PLANNING UNIT REPORT
DEPARTMENT OF PLANNING AND DEVELOPMENT
September 27, 2005

ZONING MAP AMENDMENT, I.D. 01851 LOCATED AT 1833 WINNEBAGO STREET:

DATE: September 29, 2005
TO: Plan Commission
FROM: Larry D. Nelson, P.E., City Engineer *[Signature]*
SUBJECT: 1833 Winnebago Street Planned Unit Development (GDP/SIP) & Demolition

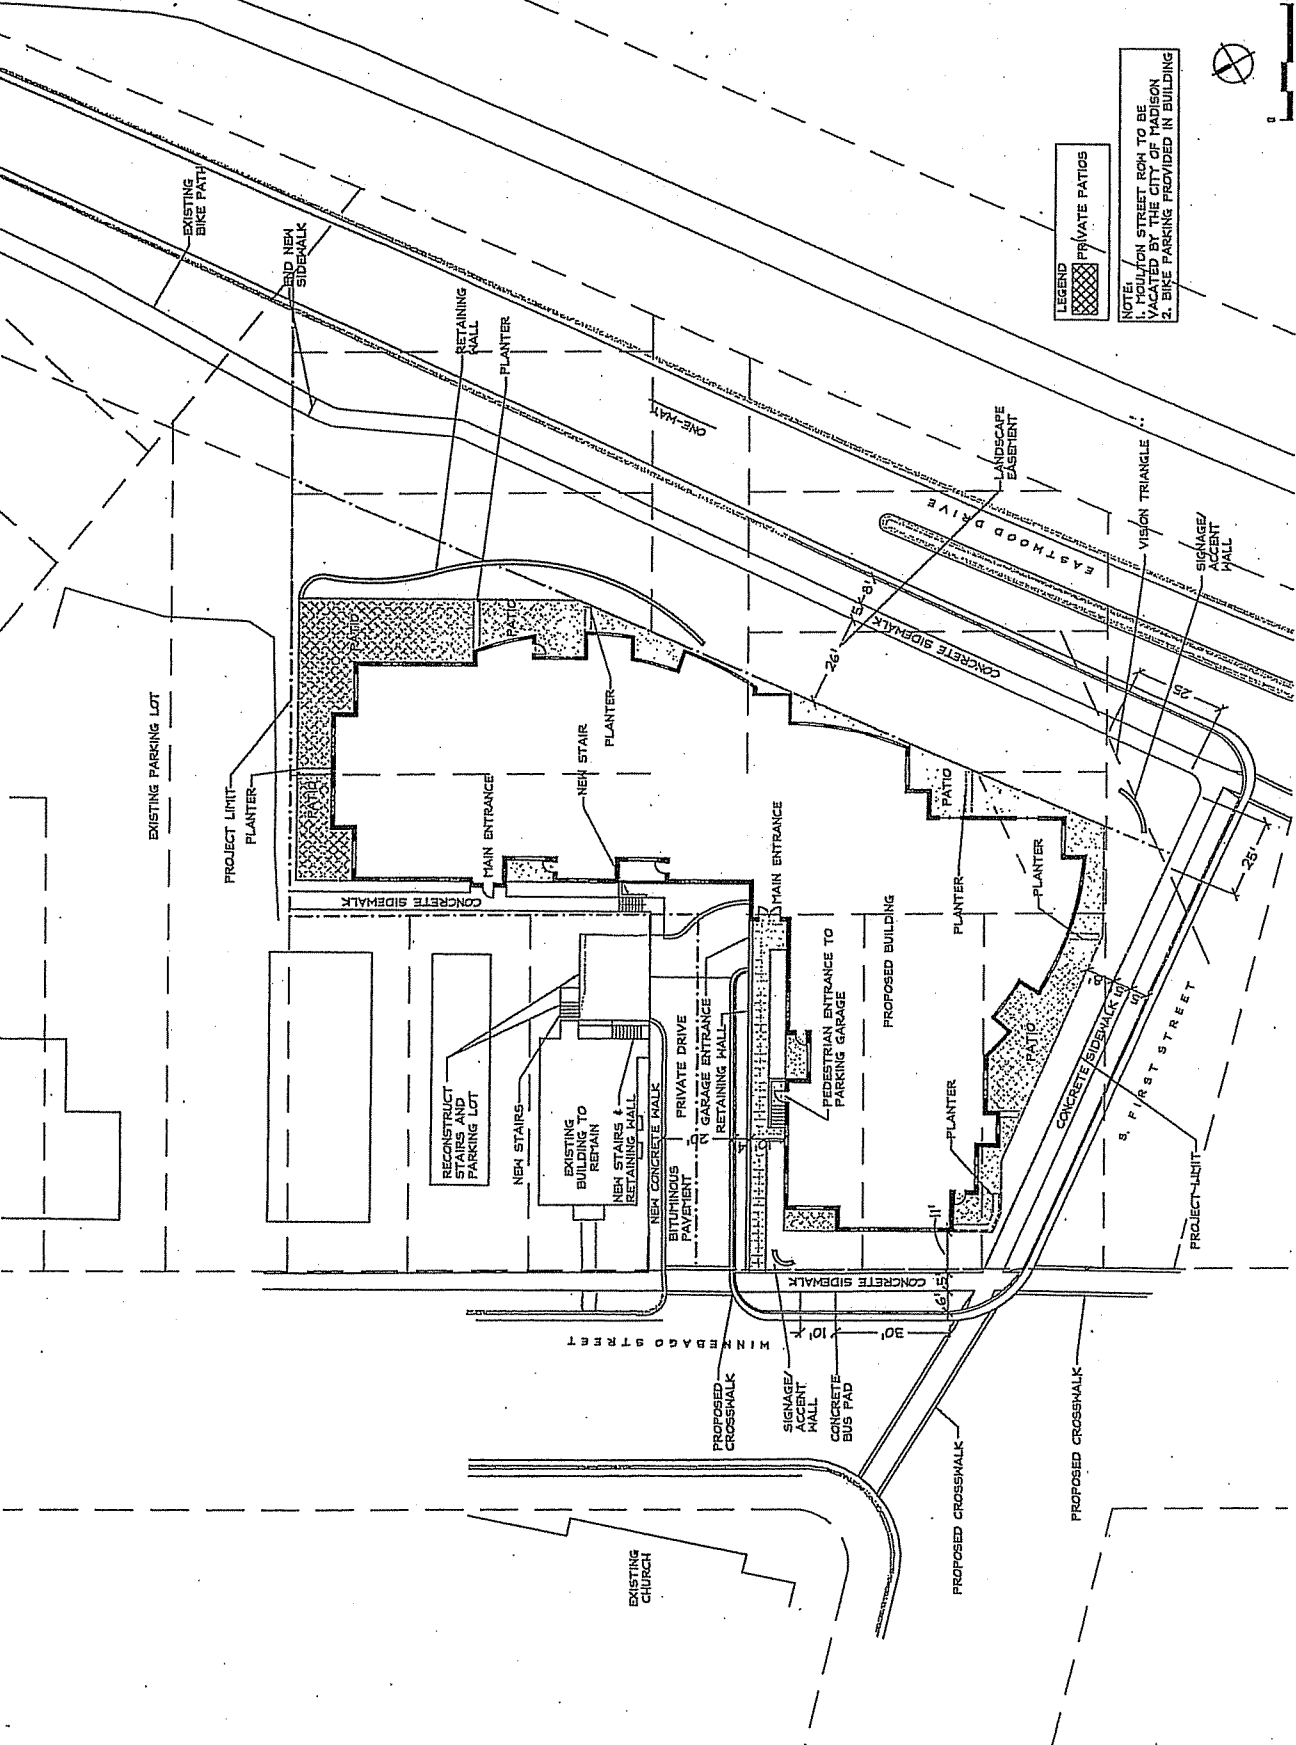
1. The applicant shall install a concrete passenger boarding pad on the south side of Winnebago Street, approximately 5 feet west of the corner radius of the private drive. (Approximately ten feet east of location shown on sheet C7 submitted 28 June 2005). The concrete pad shall occupy the full distance of the terrace, measure 10 feet in width parallel to the street, and lie flush between the sidewalk and the top of curb.
2. The developer shall revise the location of this concrete passenger boarding pad on the final documents filed with their permit application so that Metro Transit may review and approve the design.
